# City of Mississauga Department Comments

Date Finalized: 2023-10-25 File(s): A397.23

Property Address: 3873 Brandon Gate Drive

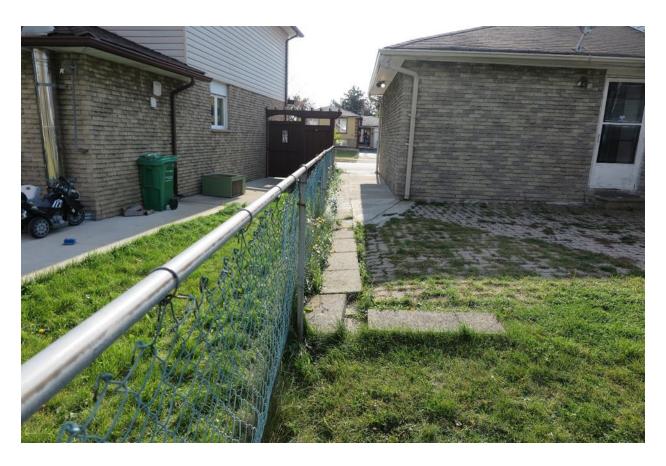
It should be noted that this property has a rear to front drainage pattern, meaning that the rear yard is at a higher elevation and all the drainage was designed to be directed to the front. From our site inspection of this property, we observed that the owner has constructed a concrete walkway on the interior side abutting the existing garage which is impeding the drainage from the rear yard and causing the drainage to be directed to the abutting property first and then directed towards the front. We are bringing this to the applicant's attention as through the Building Permit Process at the time of Grading Review, this existing condition will have to be rectified and an adequate drainage swale will likely have to be constructed on the applicant's lands. This may create a problem as both a walkway and a drainage swale will not be able to be accommodated within the side yard.
